Submission 2071 (Brian Stanke, City of San Jose Airport Department, July 1, 2020)

Draft EIR/EIS for California High-Speed Rail, San Jose to Merced Project Section

Appendix 3.11-B Airport Obstructions

Figure 2 Source: High-Speed Rail Authority

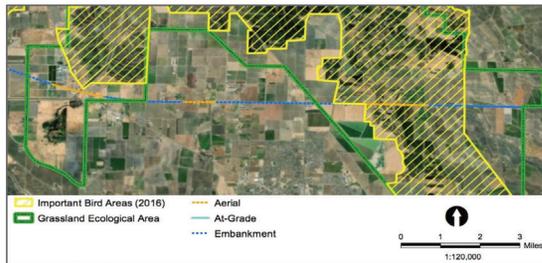
Instead of using the established GEA boundary, the DEIR/EIS uses the boundary of the National Audubon Society’s “Important Bird Area” (IBA), which occupies a smaller boundary within the larger GEA boundary.¹⁰³ As shown in Figure 2 below, the GEA boundary encompasses much more of the Project’s alignment than the IBA boundary. The train passes through two portions of the GEA but only one portion of the IBA. Entire miles of the proposed aerial and embankment segments of the train are within the GEA but not within the IBA:

Figure 1. Proposed wildlife culverts as mitigation. Pacheco Pass Preferred Alternative 4 kml file with JM_FRA_Footprint_With_Parcel_Alt4 and JM-Alt 4_Record PEPD_KMZ_05162019.

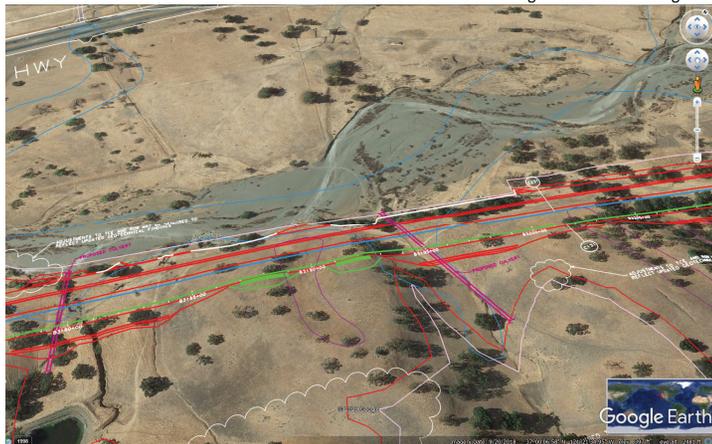
- **Crossing A: B3161+34: 130 feet long by 40 feet wide by 23 feet high.**
- **Crossing B: B3174+00: 144 feet long by 40 feet wide by 38 feet high**
- **Crossing C: B3197+00: 165 feet long by 40 feet wide by 38 feet high**
- **Crossing D: B3209+98: 185 feet long by 40 feet wide by 38 feet high**

Crossings would conform to the minimum spacing and dimensions set forth in the WCA (Authority 2020a: Appendix C), unless different dimensions or frequencies are specified in authorizations issued under the FESA or CESA. Additionally, to the extent feasible, specific designs would incorporate the features outlined under BIO-MM#77 to facilitate wildlife movement through dedicated crossings.

Figure 2. Pacheco Pass Preferred Alternative 4 kml file with JM_FRA_Footprint_With_Parcel_Alt4 and JM-Alt 4_Record PEPD_KMZ_05162019.

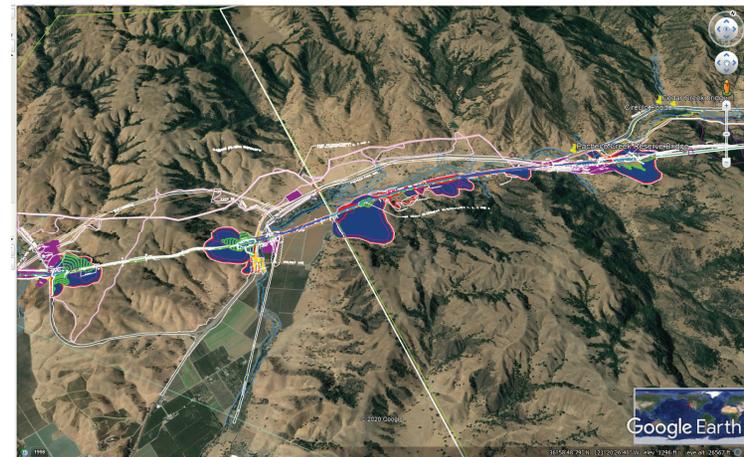
Comment 43: **HSRA did not evaluate if the rail could go on bridge for a short section in the cut and fill (Figure 2 and 3) why wasn't this analysis done for the Pacheco Pass?**

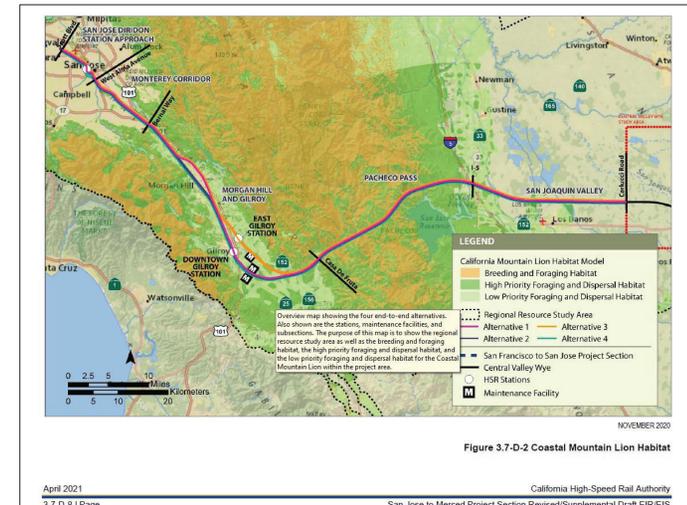
The Pacheco Pass area that will be permanently impacted consists both of high priority and low priority foraging and dispersal habitat. Please see revised HSR DEIR Figure 3.7-D-2 Coastal Mountain lion habitat below. Chris Wilmers has also noted in his comment letter that the current HSR design and proposed mitigation measures will have a significant effect on the genetic status for mountain lions in the Pacheco Pass linkage area.

Will HSRA include adequate mitigation ratios for permanent impacts to both high and low priority foraging and dispersal habitat for mountain lion in the FEIR/FEIS?
